Rezoning Transportation Analysis

Petition Number 2016-089 Updated 5/24/2016

Location Approximately 4.35 acres located on the south side of DeArmon Road between

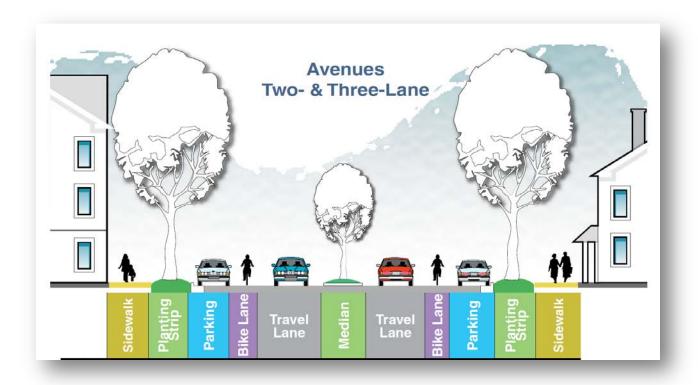
1. The petitioner should revise the site plan to identify and construct the pavement, curb line, planting strip and sidewalk in accordance with the City's future plan along the site frontage along DeArmon Road. Per the Prosperity Hucks Area Plan (see below) the site plan should show curb and gutter 24' from existing centerline and right of way dedication 40' from existing centerline of DeArmon.

CDOT recommends coordination with Kristie Kennedy (Engineering Property Management, 704.336.6194) to confirm or correct the cross section in the Prosperity Hucks Area Plan (see below) to conform to the City's Farm to Market upgrade project.
